Service Bulletin

Release of NX 21.00 SU1, XRDI 20.1 and ASC 6.1

Copyright © 2018 Agfa NV | Document ID: 67130834 | service_bulletin_template_v11

Figure 1

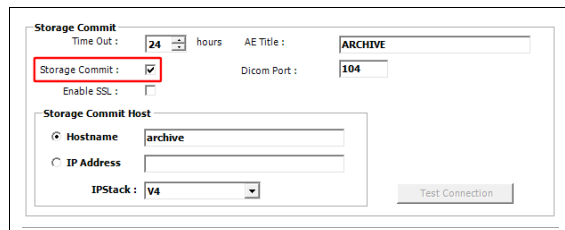
1.4.3 Disk cleanup does not work if archive is configured for storage commit [PRB2000171]

Symptom If NX 21.00 is configured to send images to an archive with “Storage Commit”, the image is properly sent. However due to a software bug no confirmation is received on NX to confirm the archive. This way the images are not deleted on NX. The exam stays in the queue. Images accumulate on NX. This software issue is present in all CR and DR systems with NX 21.00, where images are sent to an archive with “storage commit”.

Cause Software issue introduced in NX 21.00, as side effect of new storage feature for DR 800.

Solution Install NX 21.00 SU1. Refer to section 3. After the update it is important to check for sessions that are “waiting for storage commitment” or “failed to archive”. Refer to section 3.1.
